**US Army Corps
of Engineers ®**
Wilmington District

PUBLIC NOTICE
MODIFIED DESIGN

PRINCEVILLE, NORTH CAROLINA FLOOD RISK MANAGEMENT
DRAFT INTEGRATED FEASIBILITY REPORT AND ENVIRONMENTAL ASSESSMENT

Figure 3

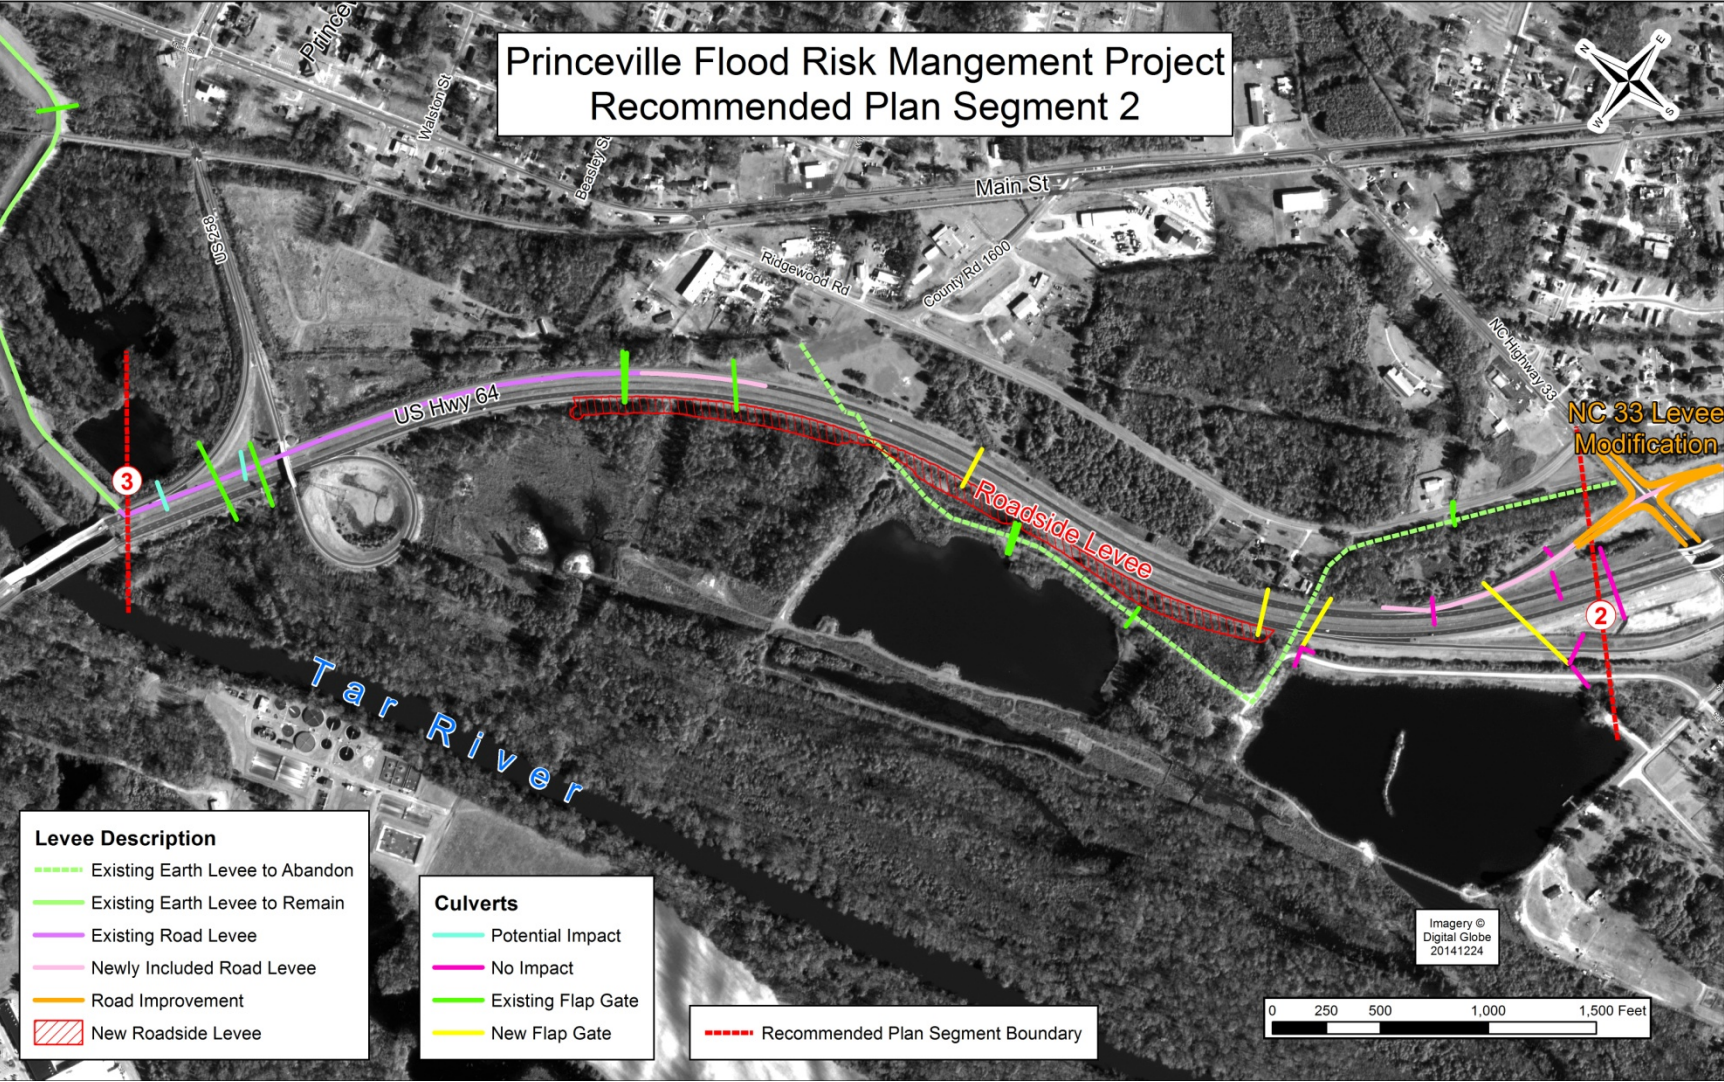
Segment 2: The revised design omits the previously proposed construction of a 300-foot flood wall on the eastern side of Highway 64 and includes the installation of a “shoulder” levee along a low spot on the existing Highway 64 western embankment, to prevent overtopping up to the design event water surface elevation. The “shoulder” levee would be 3,450 linear feet long, with a fill volume of 61,500 cubic yards, a portion of which would occupy approximately 4.54 acres of wetlands on the River side of the existing levee. Mitigation for these wetland impacts is described in detail below. Segment 2 begins at the end of Segment 1 and runs north to the existing northern levee reach near the westbound bridge abutment of Highway 64 over the Tar River. The original design included the installation of flap gates on four (4) drainage pipes in the realigned levee. The revised design proposes flap gates at six (6) culverts within this realigned levee (Figure 3).

Figure 4

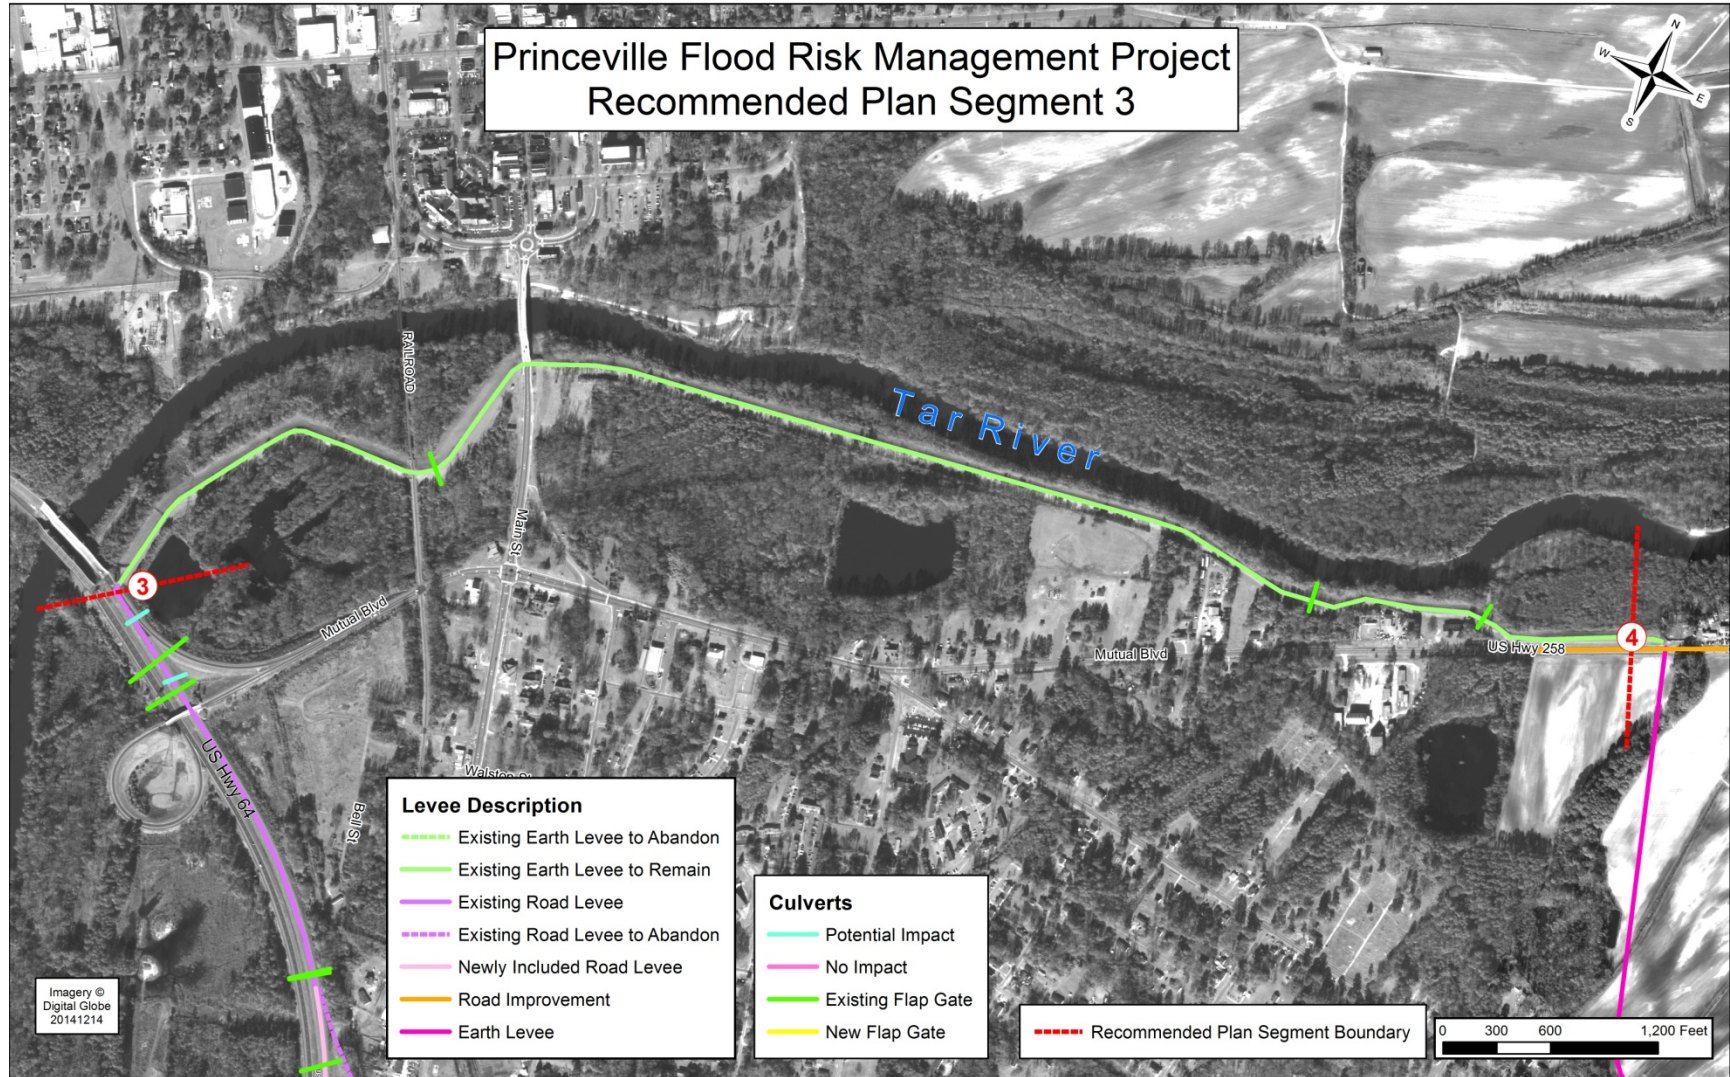
Segment 3: The only design change consists of removing the originally proposed stability berm, which is no longer required (Figure 4).

Figure 5

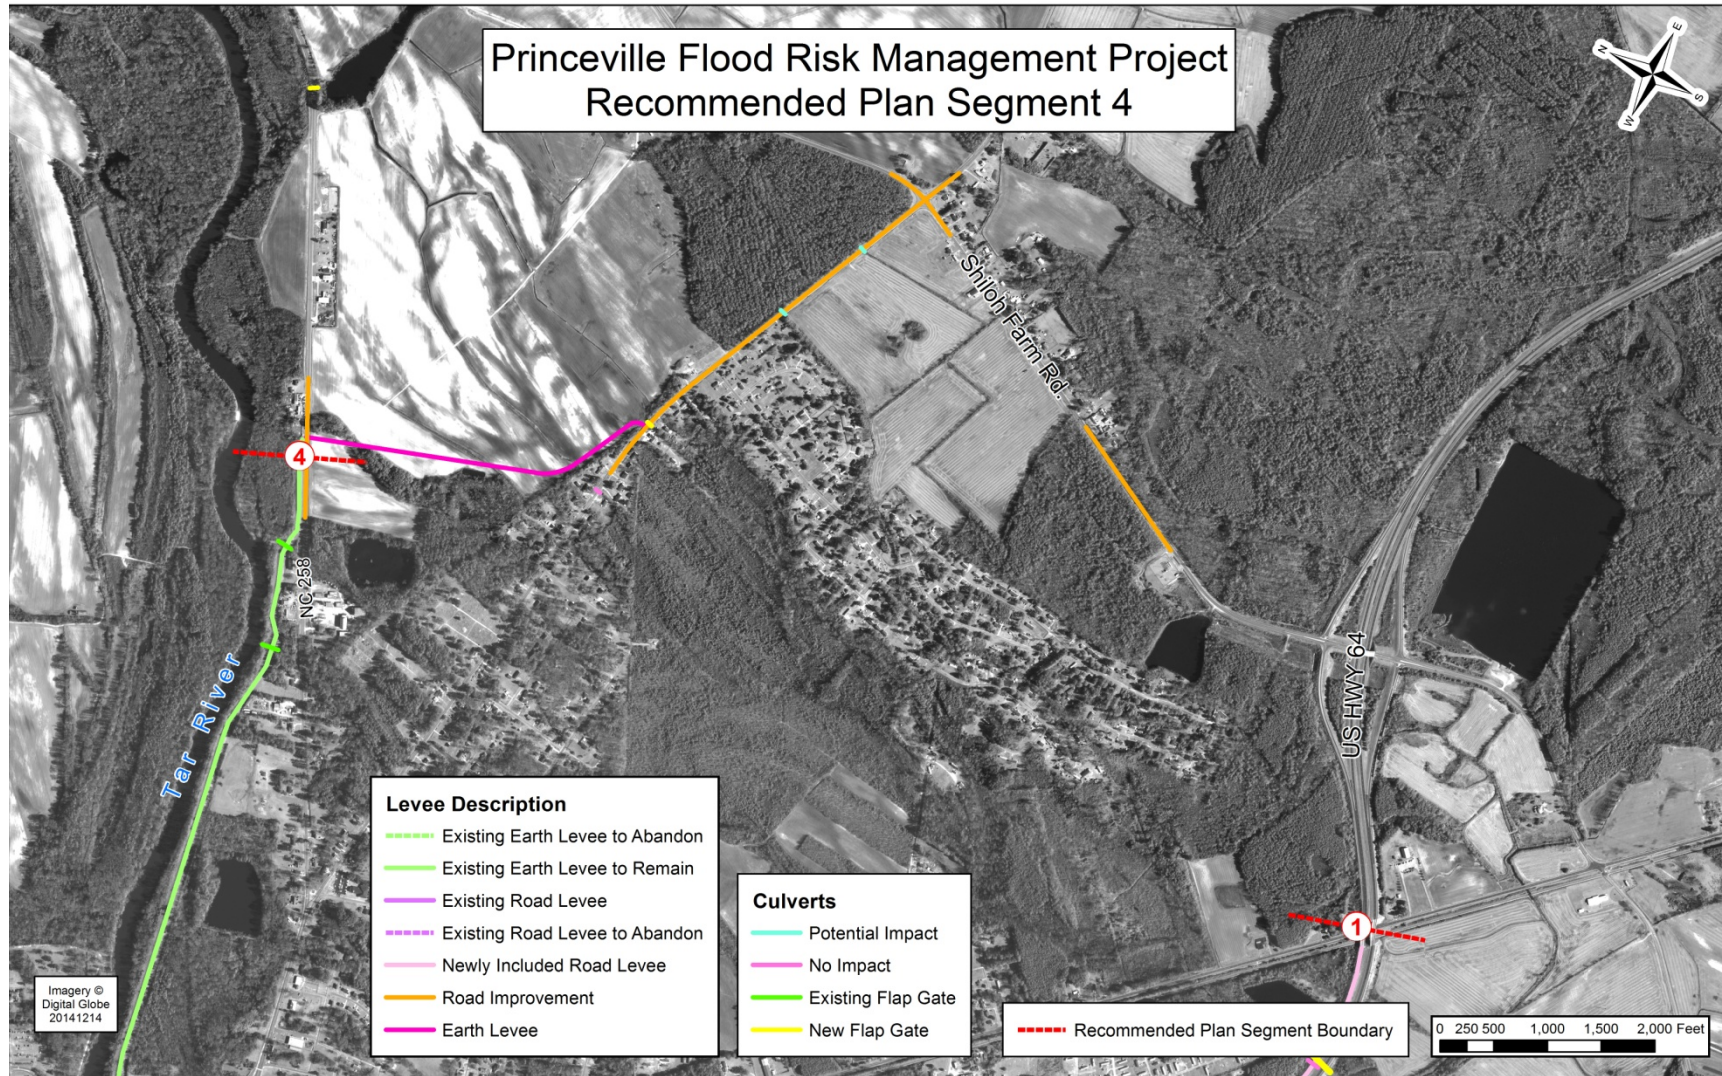
Segment 4: The revised design would extend Harris Hill Lane by 800 feet, to provide construction access and to also serve as a second avenue for egress to connect the eastern portion of Princeville to a hurricane evacuation route. Other Segment 4 project features remain unchanged. The original design required the adjustment of about 15 residential and 3 commercial driveways and one subdivision entrance. Modifications in this segment may potentially require elevating up to 27 driveways and Strickland Drive, to meet the new road elevations. All such work will comply with NCDOT’s specifications and will meet current design standards (Figure 5).

POTENTIAL WETLANDS IMPACTS

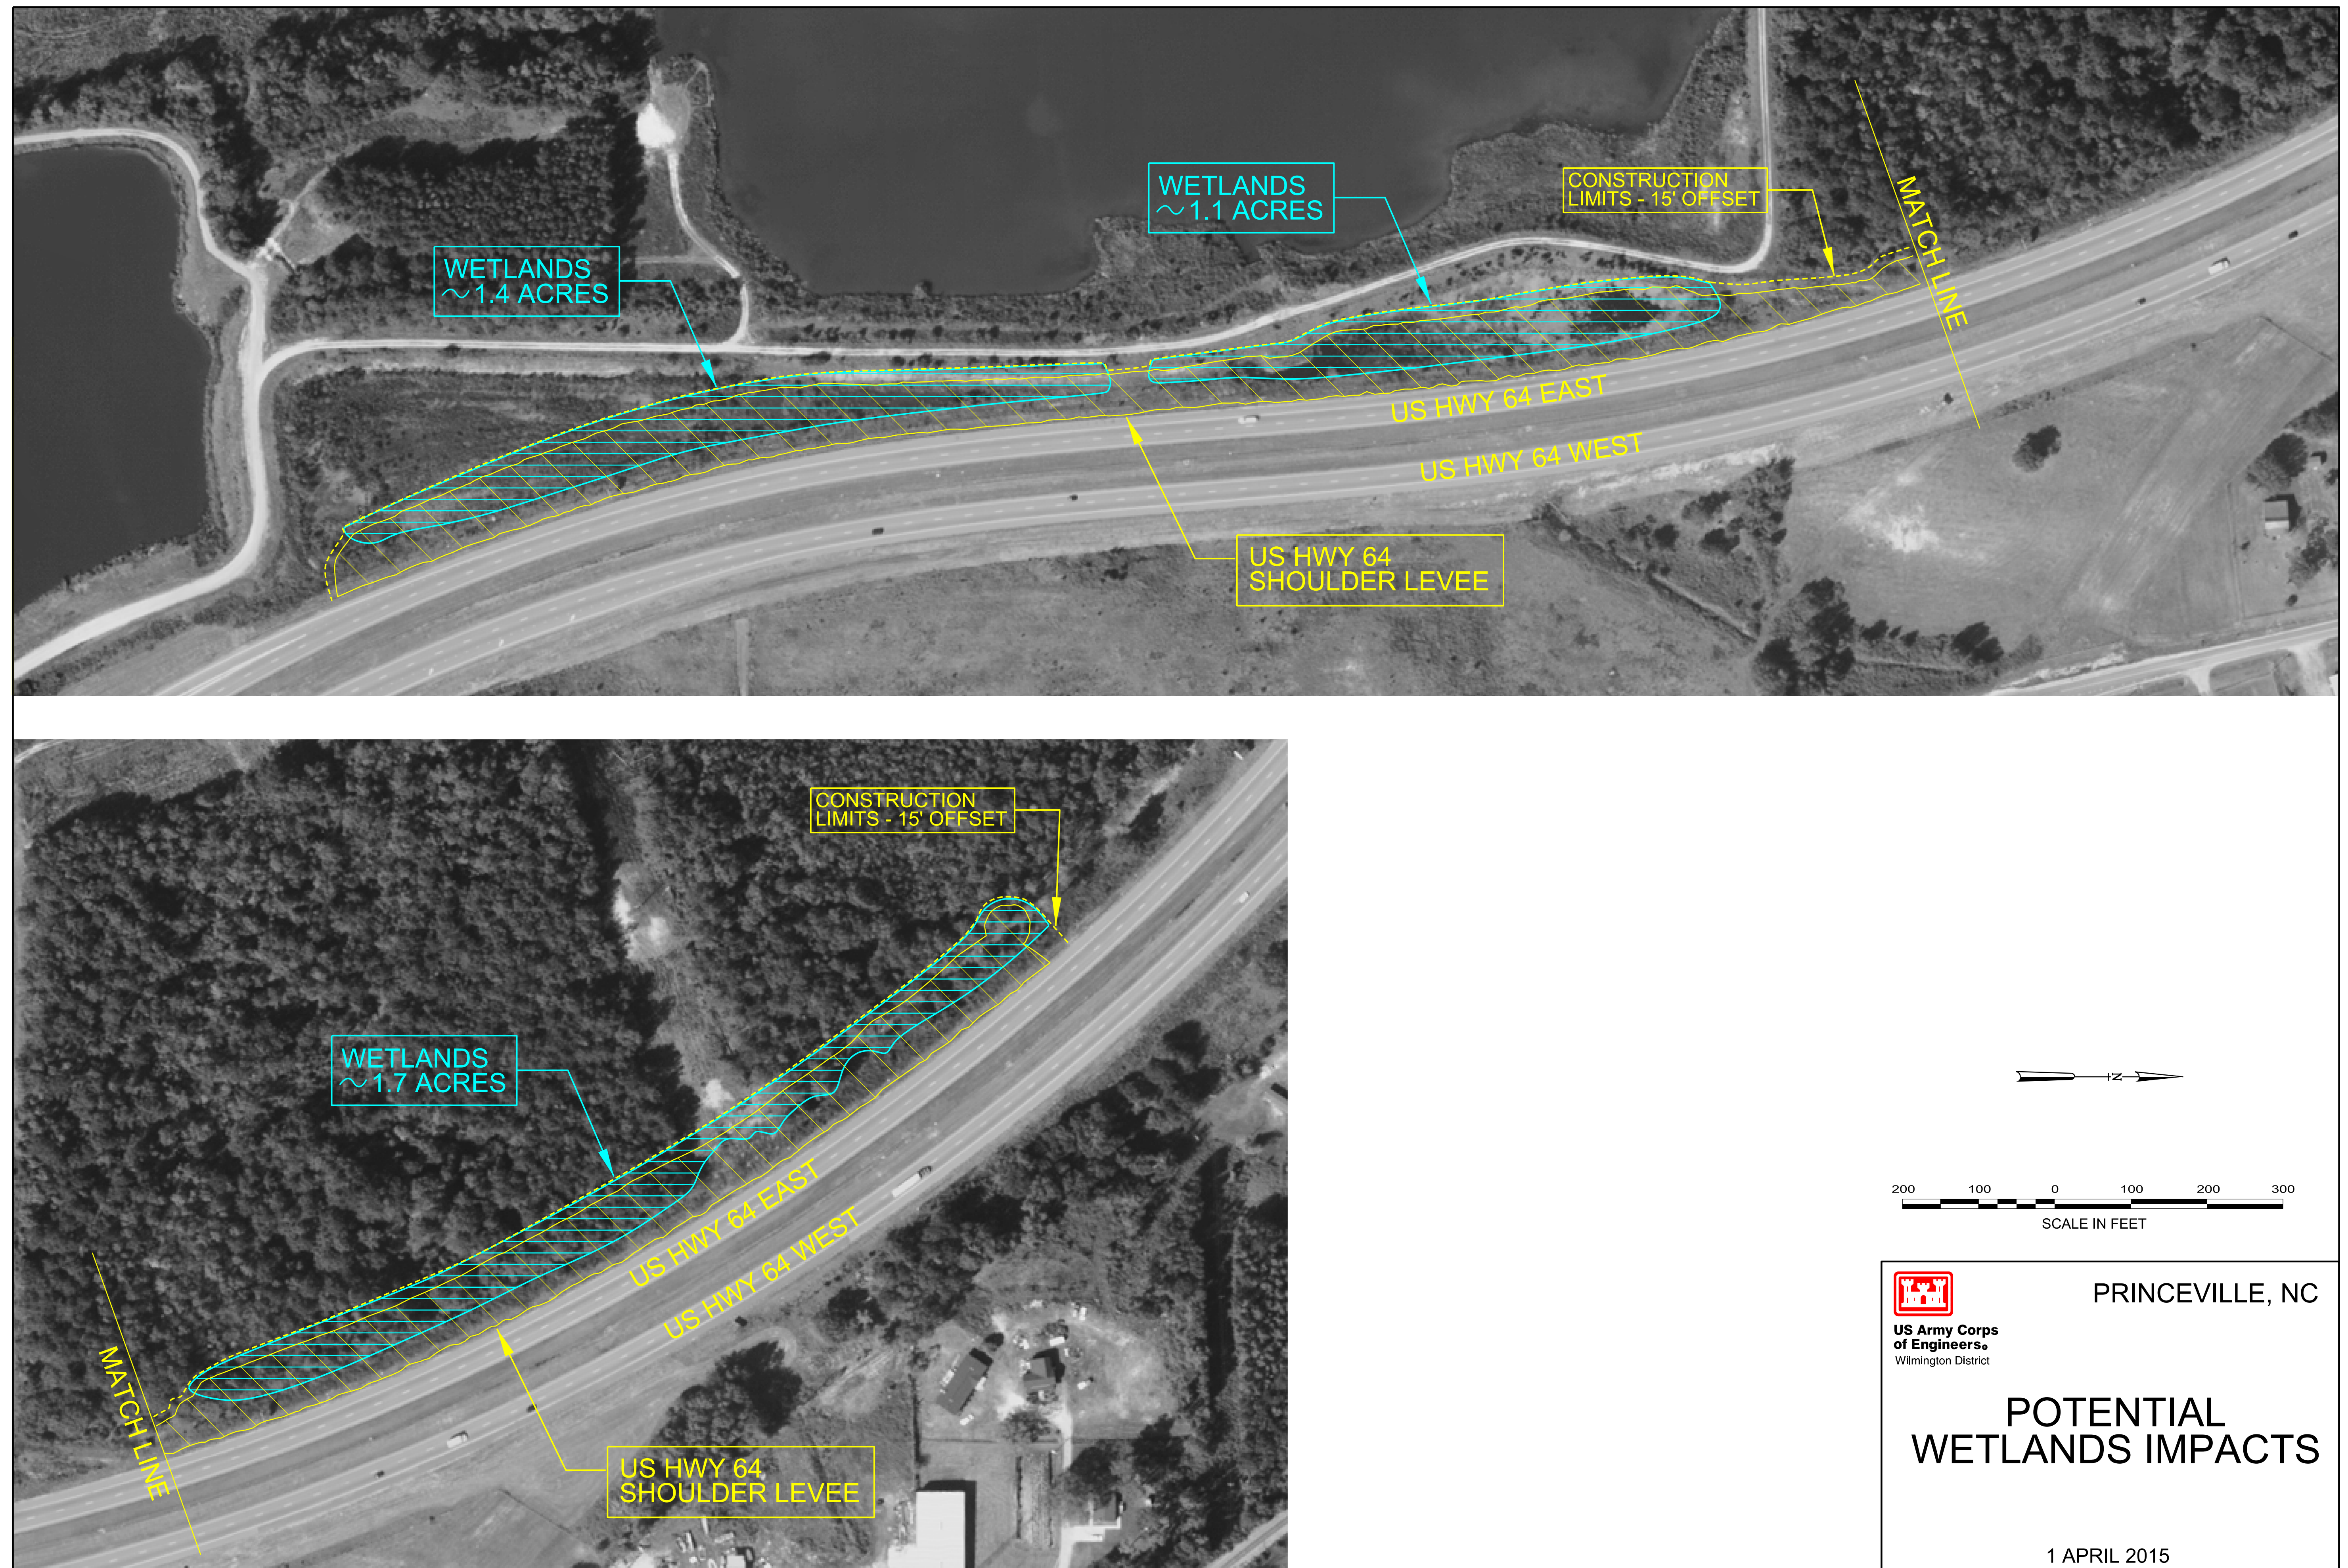
Impact Analysis for the Proposed Revised Design: The proposed project modifications will result in additional impacts to riparian wetlands adjacent to the Tar River (Figures 6 and 7). The new levee alignment along the west side of Highway 64 would impact approximately 4.54 acres of riparian wetlands adjacent to the Tar River. These are the only new impacts that would result from implementation of the proposed project modifications. Also, there would be no new impacts associated with the construction access or staging areas. With the exception of the new wetland impacts in Segment 2, the 2014 Report/EA adequately addressed all impacts associated with the project.

Proposed Mitigation for Wetland Impacts: The proposed mitigation will be based on a wetland function assessment that ensures adequate mitigation for impacts to approximately 2.50 acres of low functioning wetland area and 2.04 acres of high functioning wetland area. The proposed mitigation includes purchase of 2.50 acres of in-lieu fee mitigation credit from the NC DMS for impacts to the 2.50 acres of low quality habitat/ low functional value wetlands and purchase of 4.25 acres of in-lieu fee mitigation credit for impacts to the 2.04 acres of high quality habitat/high functional value wetland. Resource agencies support this approach and NCDMS confirmed they have lands available for purchase as mitigation in the Tar River watershed.
